STAFF REPORT TO THE WILLAMINA PLANNING COMMISSION

FILE: #SDR 23-02 and #CUP 23-01 “B&B Auto Service”

PROPOSAL: **Conditional Use Permit approval to operate an automotive repair service business in the C1 – General Commercial Zone, and concurrent Site Plan Review approval to convert an existing warehouse shop structure with five overhead bay doors into a new automotive repair business with an office, waiting room, paved parking, landscaping, etc. Vehicles may be stored behind (north of) the building abutting nearby residential. The large gravel lot zoned R3 – Medium Density Residential is only proposed to provide an access easement to the rear of the new business, and will not be developed at this time.**

D. PROPOSED SITE PLAN SUBMITTED BY APPLICANT (cropped to zoom)

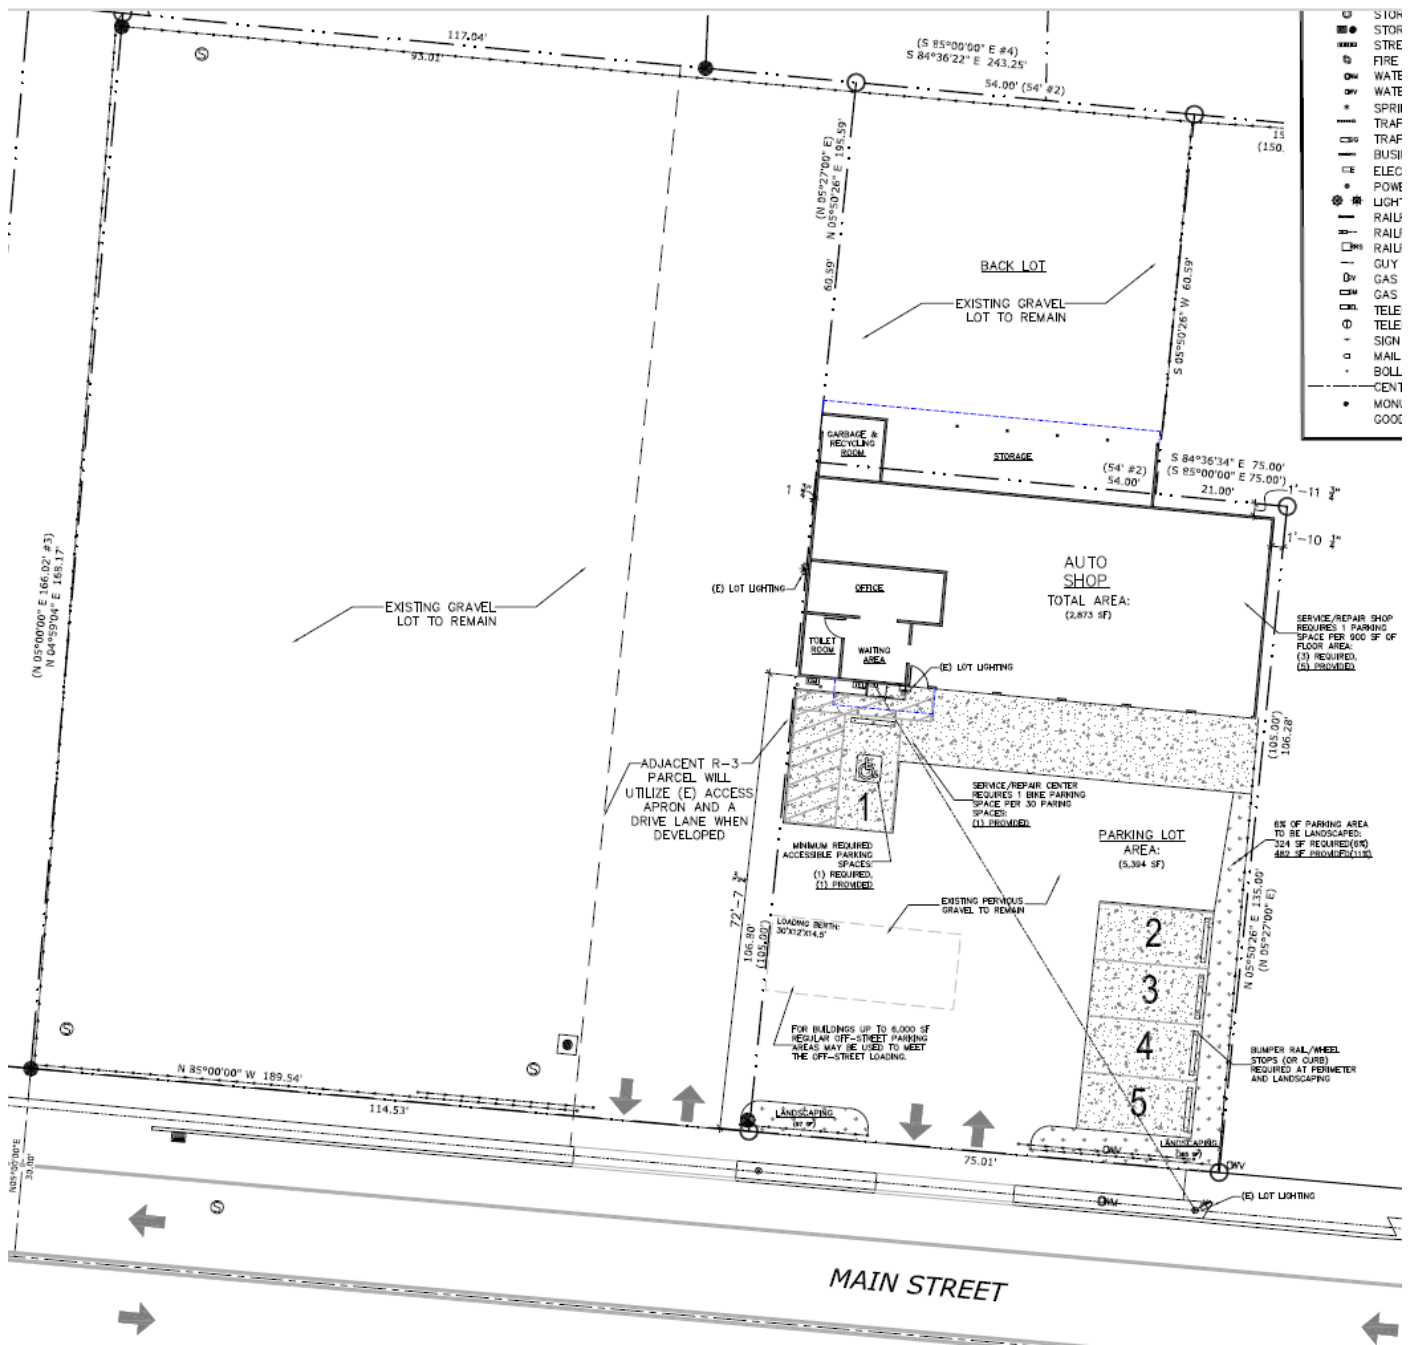
Pursuant to WDC 2.203.08(A) *Surfacing*, all driveways, parking, and loading areas shall have a durable, hard surface. Further, parking spaces shall be a minimum of 9 feet wide by 18 feet in length, and two-way driveways shall be paved a minimum width of 20 feet. Not all portions of the front or rear parking lots are proposed to be paved on the submitted site plan. These standards are included as a recommended condition of approval.

FINDINGS: The applicant's resubmitted site plan shows landscaping strips along the front of the property abutting Main Street, as well as the east side of the parking area. Additional detail is needed to confirm compliance with the adopted standards.

The submitted site plan shows the garbage and recycle receptacles are enclosed in the rear of the building. The site plan can be found to comply with the screening and buffering standards through the applicant's compliance with the recommended conditions of approval regarding parking lot perimeter landscaping and screening fence along the rear vehicle overflow parking/storage area.

3. **REVISED SITE PLAN.** Applicant shall submit a revised site plan for City review and approval demonstrating compliance with the adopted conditions of approval.

9. LANDSCAPING. On a revised site plan, applicant shall demonstrate compliance with the landscaping standards of the C1 zone and WDC 2.207 Site and Landscaping Design. Specifically, a minimum of 10% of gross site area (to include both C1-zoned properties, but not the R3-zoned property), and a minimum of 3-foot landscaping perimeter around the parking lot(s). If planted, stormwater detention areas may be counted toward overall landscaping count.

OVER-ALL PHASE-2 SITE PLAN

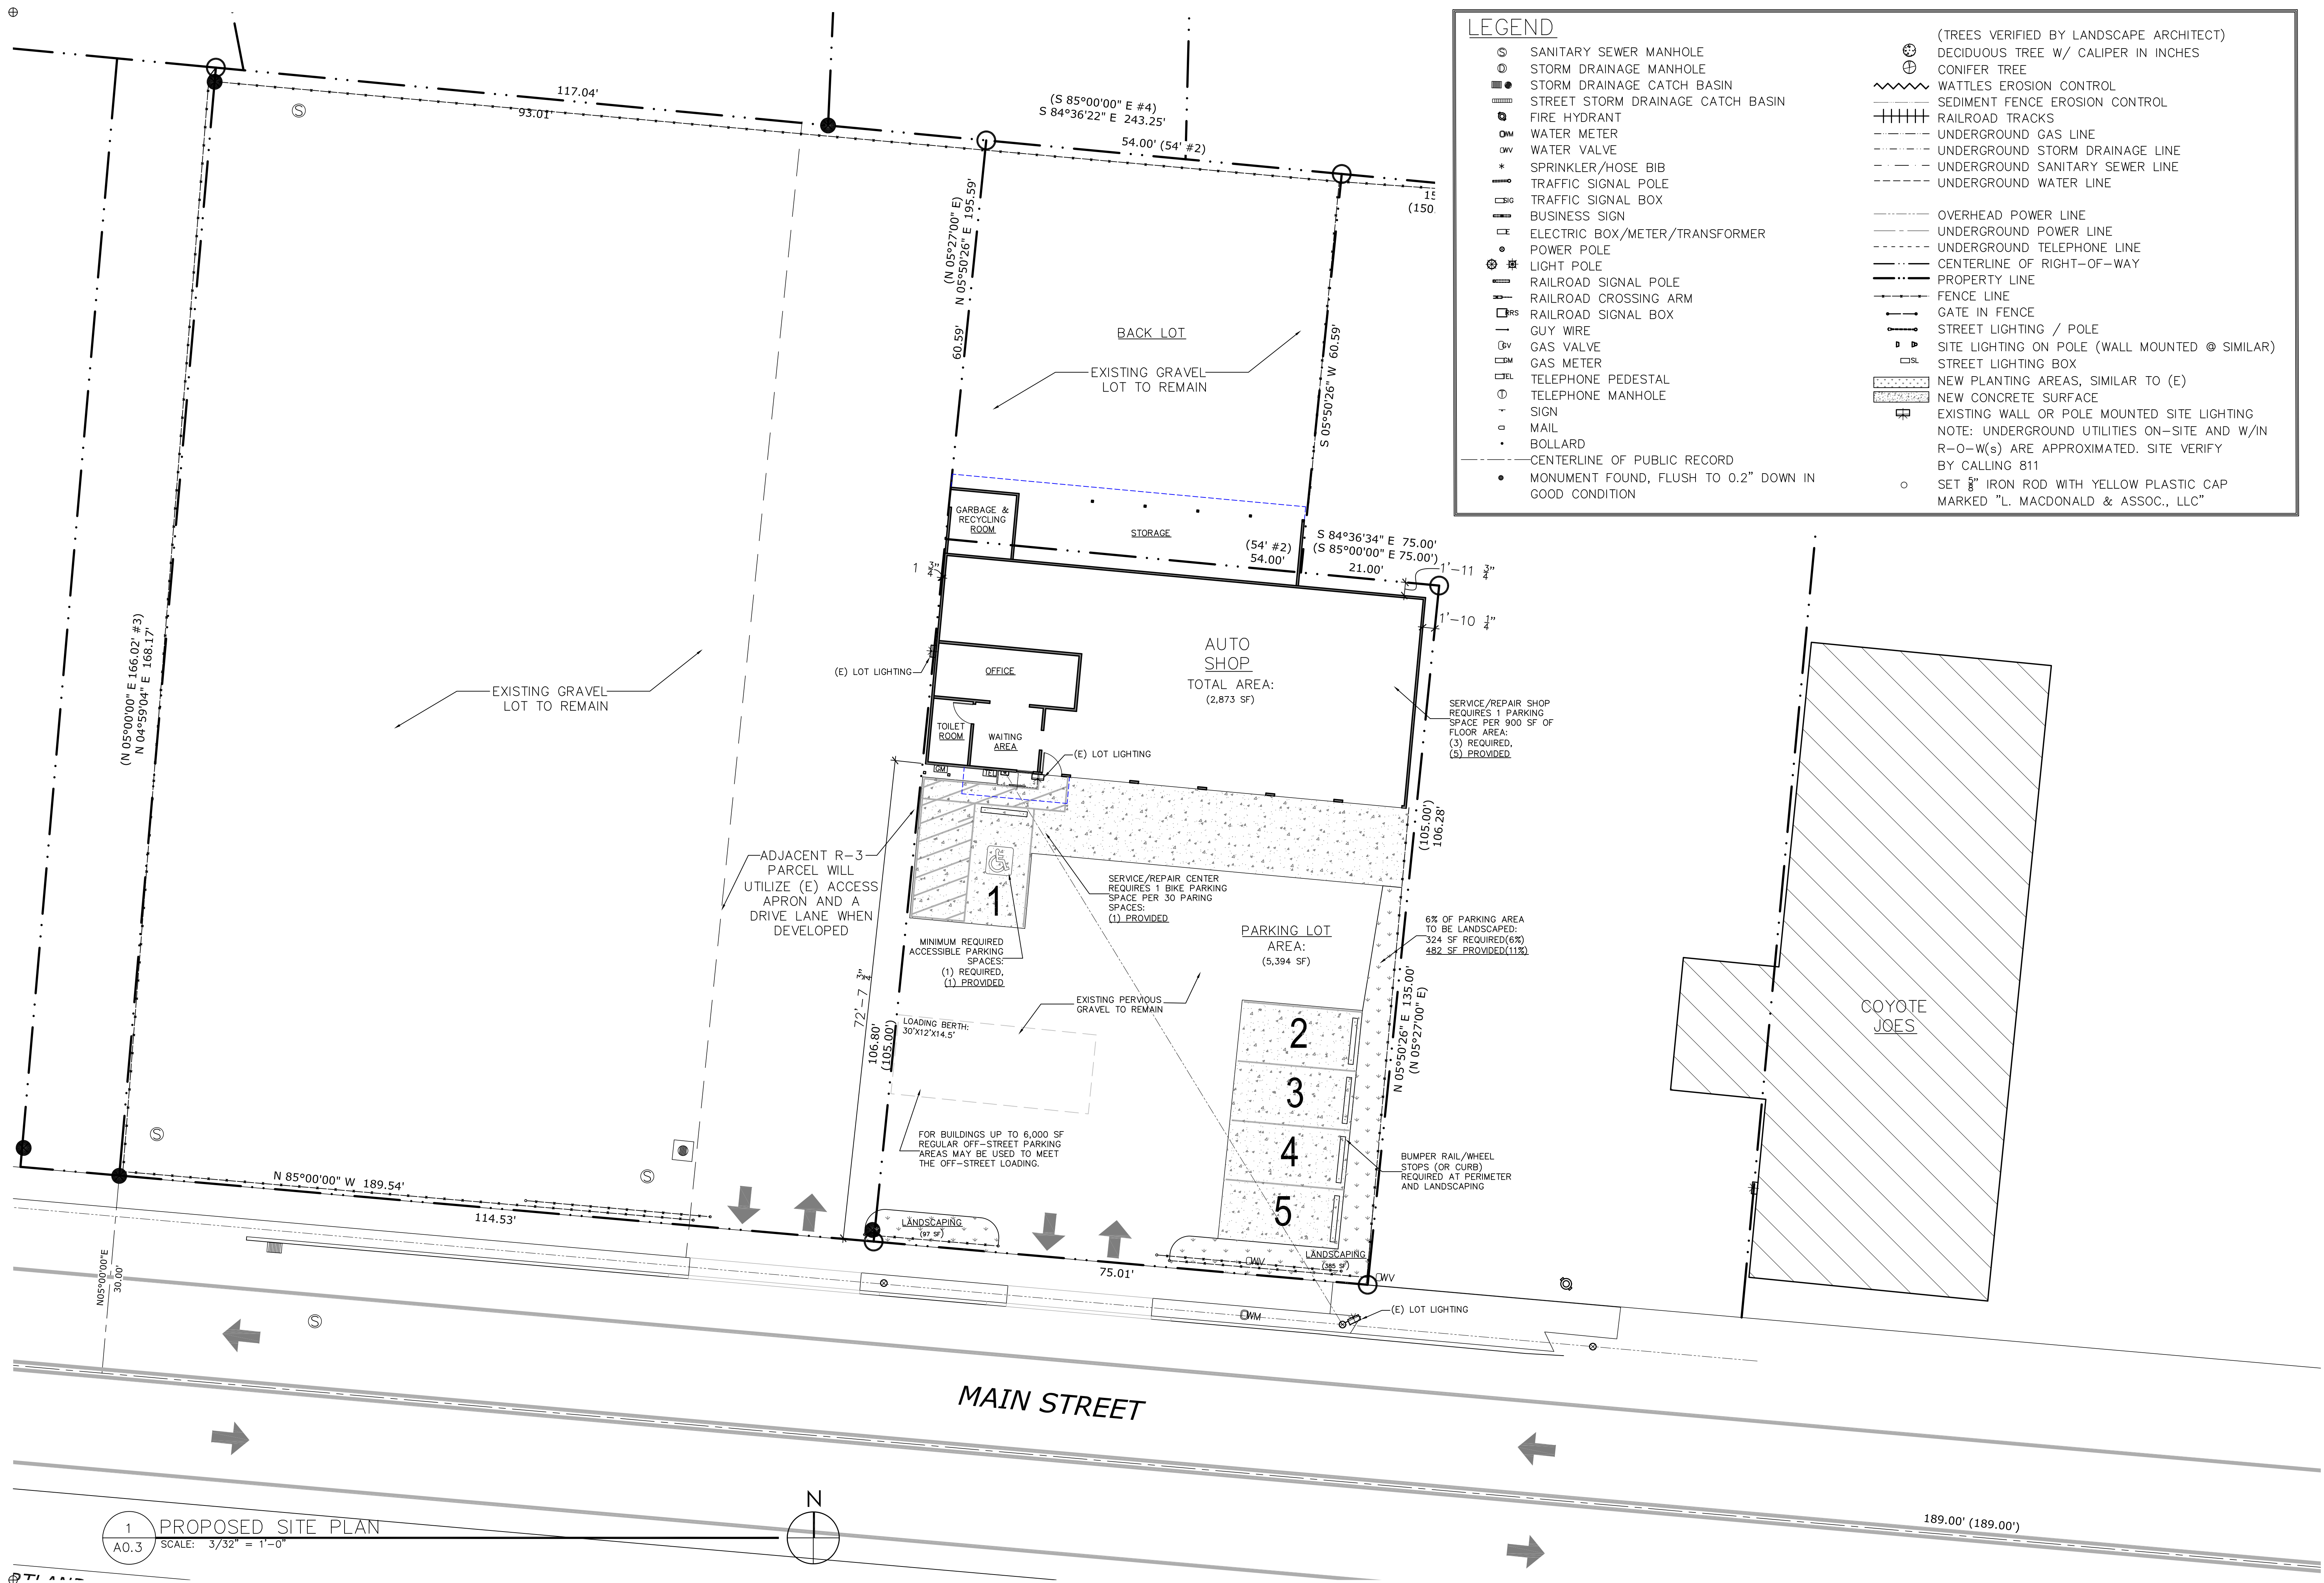
FINDINGS: The subject properties have two existing driveway drops onto NW Main Street; one to the C1 commercial property and the other to the R3 residential property. The applicant states that the rear (north) side of the existing building may be used for overflow vehicle storage/parking. That commercial property is currently landlocked, as it does not appear to have legal access to the public street right-of-way. For this reason, the applicant will need to record an access easement across the R3 property to ensure that the rear lot retains legal access, should the R3 property change hands. Alternatively, the applicant could perform a lot consolidation to combine the two commercial properties. A recommended condition of approval is included requiring the applicant to demonstrate an easement is recorded between the properties.

8. ACCESS EASEMENT. To prevent the rear C1 property from being land-locked, the applicant shall provide to the City a copy of a recorded access easement granted from the R3-zoned property to both smaller C1-zoned commercial properties, allowing access to the rear of the existing building and site circulation through both driveways.
